UNITED NUCLEAR CORP. LETTER DATED JULY 25, 1962 - DOCKET 70-36

We have reviewed the subject application requesting modified procedures for drying highly enriched UF_4 in the drying oven, and the addition of a new filter for UF_4 .

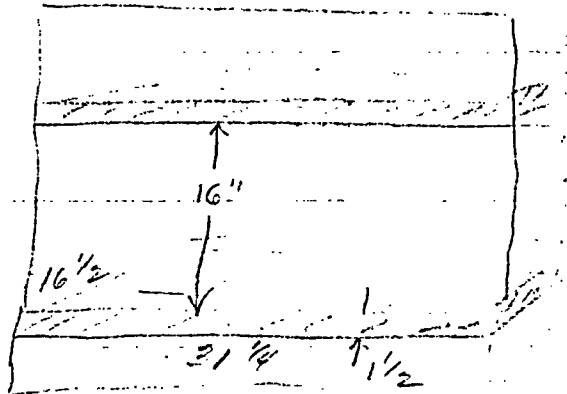
Notes: Still ok given 17" ht.
Add a new 5" dia x 12" UF₄ filter

Drying Tower - Dry UF₄ in two layers rather than one

Safe slab thk, opt mod is 1.5"

Green part will be wet but not opt

Emp. Check 10/9 (Very Conservative)

$$W = \frac{\text{Area}}{d^2} = \frac{16.5 \times 31.25}{16^2} = 2.01 \text{ Slab. UN gets 1.3 Green}$$

Note: K-1019(S) gives 12" spacing ok for two inf 1 1/2" slabs
i.e. Green is OK.

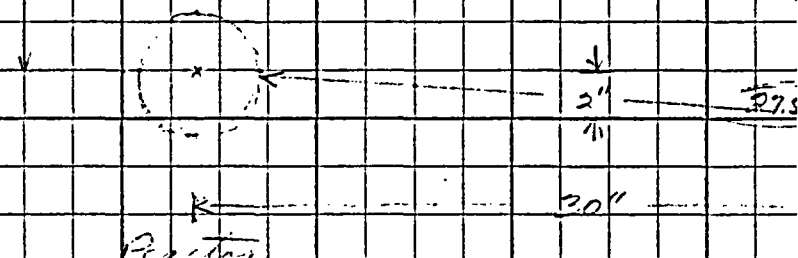
With regard to the new filter, it is of safe diameter and we agree that its location fulfills the solid angle criterion insofar as the other four pieces of equipment are concerned (see Figure 3 attached to July 23 application). However, we are unable to confirm the solid angle of 2.5 steradians, calculated at the new filter, and the solid angle subtended at a muffle box in the aisle outside of the hood. Please ask United Nuclear to furnish dimensioned sketches and a summary of the calculations for these two cases.
